Access Compliance Report

Public Rights-of-Way

Intersection ID: 10026324	Main Street: FAIRVIEW_RD	Cross Street: N/A	Location: SW
ADA ID: 600D8E8D59CE	Ramp Type: PerpDiag	Initial Pass/Fail: Fail	Overall Compliance: No
Severity Score: 65			
Codes/Mitigation Info/Possible Solution		Field Measurements/Component Compliance

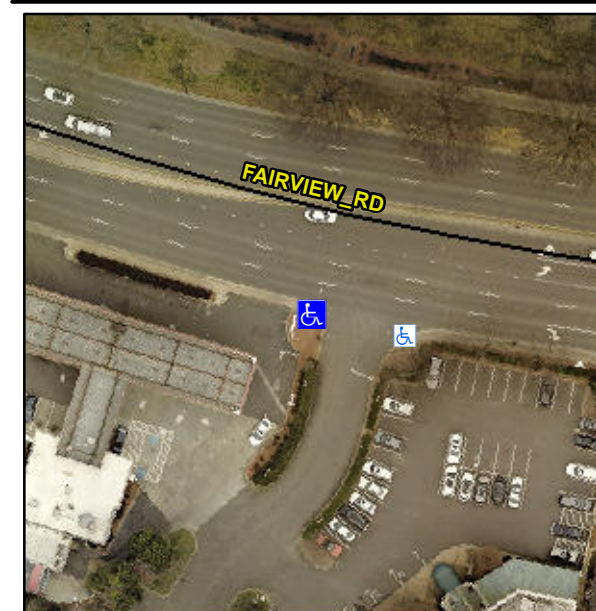
R304.2.2, R304.5.3, R302.7

Compliance	Description	Data	Compliance	Description	Data
N/A	Ramp Length (in)	37.0	No	Ramp Slope (%)	14.9
Yes	Ramp Width (in)	48.0	No	Ramp XSlope (%)	8.3
N/A	Flare Type LT	N/A	N/A	Flare Type RT	N/A
N/A	Flare Slope LT (%)	N/A	N/A	Flare Slope RT (%)	N/A
N/A	Flare Traversable LT?	N/A	N/A	Flare Traversable RT?	N/A
N/A	Landing Length (in)	N/A	N/A	DWS Provided?	N/A
N/A	Landing Width (in)	N/A	N/A	DWS Contrast?	N/A
N/A	Landing Slope (%)	N/A	N/A	DWS Length (in)	N/A
N/A	Landing X Slope (%)	N/A	N/A	DWS Full Width?	N/A
N/A	Landing Curb? (Y/N)	N/A	N/A	DWS Offset (in)	N/A
N/A	Shared Landing?	N/A			
N/A	Gutter Ponding?	N/A	N/A	Gutter Slope (%)	N/A
N/A	Gutter Lip Ht (in)	N/A	N/A	Gutter X Slope (%)	N/A
N/A	Painted X Walk1?	No	N/A	Painted X Walk2?	No
	X Walk 1 Direction	To SE		X Walk 2 Direction	To NE
N/A	X Walk 1 Width (in)	N/A	N/A	X Walk 2 Width (in)	N/A
	X Walk 1 Slope (%)	2.6		X Walk 2 Slope (%)	0.3
	X Walk 1 X Slope (%)	1.4		X Walk 2 X Slope (%)	0.8

N/A	Ramp inside XWalk1?	N/A	N/A	Ramp inside XWalk2?	N/A
	Road Slope (%)	0.5	N/A	Clear Space?	N/A
	Road X Slope (%)	1.3	N/A	Clear Space to XWalk (in)	N/A
N/A	Any Obstructions?	N/A	N/A	Storm Grate/Utility Hazard?	N/A
	Obstruction Type			Storm Grate/Utility Type	
		N/A			N/A
		No		Surface Condition? (G/P)	Poor

Remove & Replace Curb Ramp With Two New Directional Ramps or Equivalent.
